Seismic Walkdown Checklist (SWC)

Equipment ID No. I-1605-95-SPB Equip. Class¹² ZO

Equipment Description SOLID STATE PROT SYS CAR-TEN B

Location: Bldg. CONTROL Floor El. 220 Room, Area 165

[Signature] / JUSTO S. CHACON 9/27/12

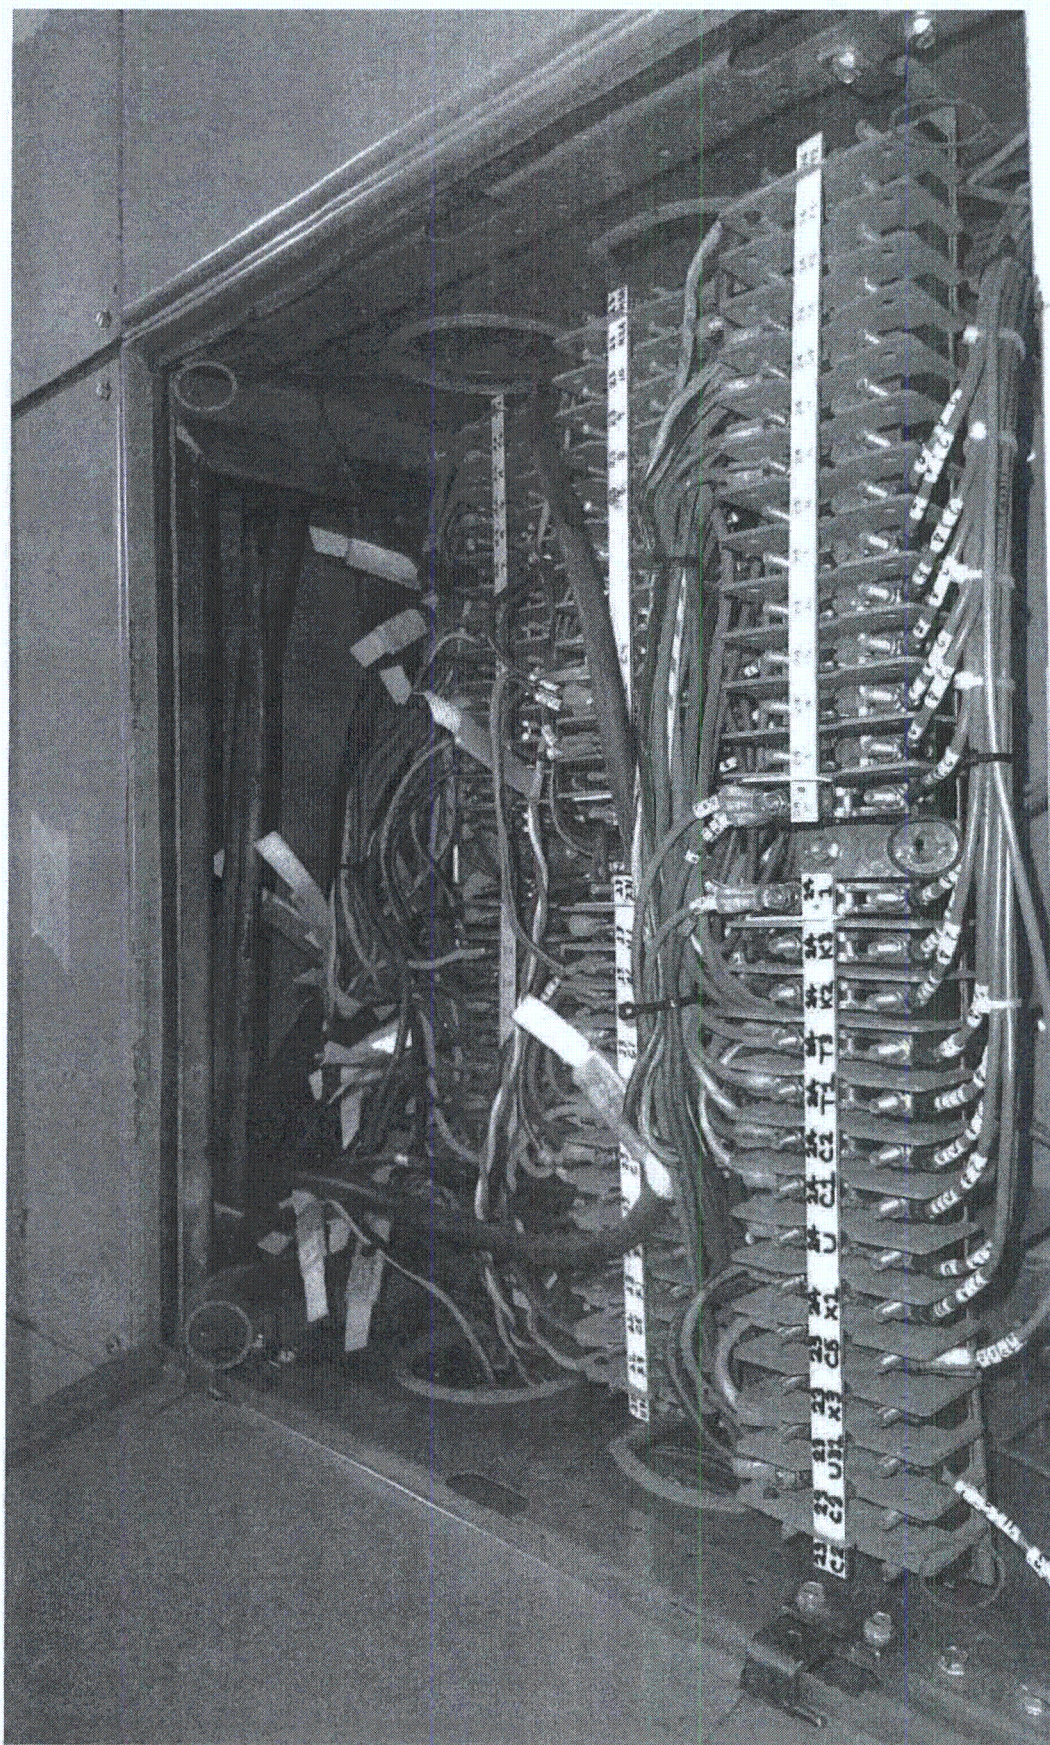
- ① There was found some missing nuts and screws used to secure cover plates and protective covers. The seismic walkdown team judged that these findings do not represent an operability or vulnerability concern.
- ② There was found some missing screws used to secure terminal blocks. The seismic walkdown judged that this condition needs to be evaluated for seismic vulnerability.

Both findings were documented on the condition report 325343.
